NEWPORT NEWS PUBLIC SCHOOLS PURCHASING DEPARTMENT

NOTICE OF AWARD

Description of Work/Products to be furnished: **Heritage High School Main Distribution Switchboard Replacement**

Questions and Responses

Cable Limiters

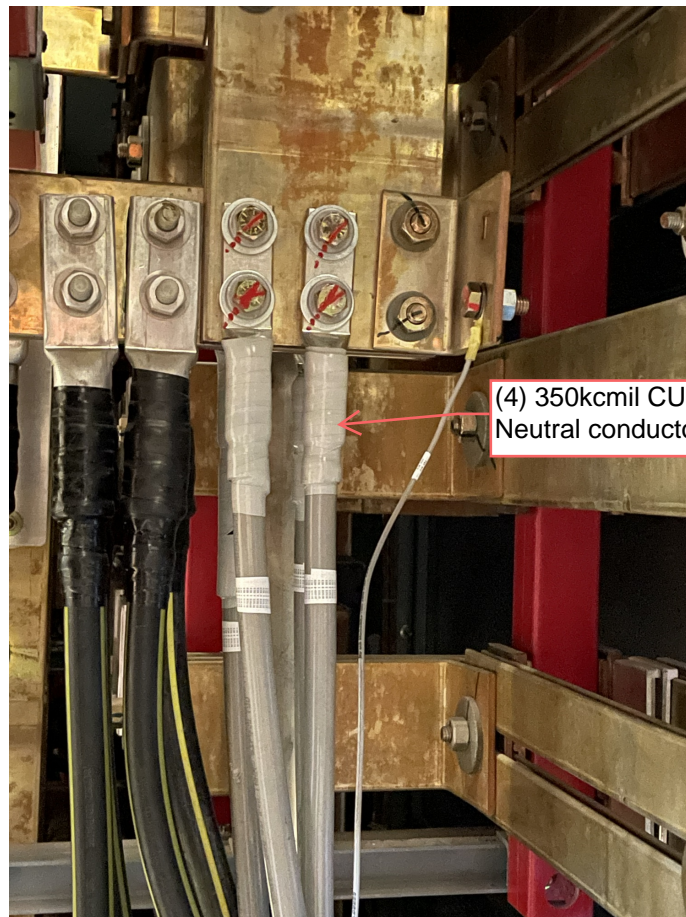
Question 9 According to Dominion Energy's Blue book section 760.8. Connection of customer generation is not allowed on the line side of metering equipment and will not register correctly. This connection is not available from the manufacturer of the new switchboards within the Dominion Energy section. Therefore, is it the responsibility of others to provide a means to and reconnect the photovoltaic system to the NEW switchboard? **Answer:** Per Sun Tribe, the termination will be on the load side of the CT compartment directly to the bussing. The contractor shall refer to the specifications provided by Sun Tribe. Contact Taylor Brown at 423-987-2210 for coordination and questions.

Question 10 The new Switchboards' Dominion Energy approved Incoming & CT compartments are manufactured to Dominion Energy's standards and have received prior approval. In accordance with Dominion Energy's blue book section 680.2 & 680.17 this section is not to be used for customer auxiliary, or are any modifications permitted. Therefore, there is no place for connection to existing photovoltaic system available from the switchboard manufacturer within a Dominion Energy approved incoming & CT compartment. Is it acceptable to provide a Dominion approved section with the responsibility for reconnecting the solar to be by others? **Answer:** The contractor shall refer to the specifications provided by Sun Tribe for the required number of lugs needed for the termination of the photovoltaic system. The required termination quantity and size shall be coordinated with the distribution manufacturer so that Sun Tribe can terminate the bussing.

- (4) 350 kcmil CU THWN-2 conductors
- Terminated with UL-listed compression lugs (2-hole NEMA pattern)
- Connected to the neutral bus using grade 5 hardware with flat washers
- Conductors shall be reused and re-terminated in the new switchboard as shown in the existing configuration
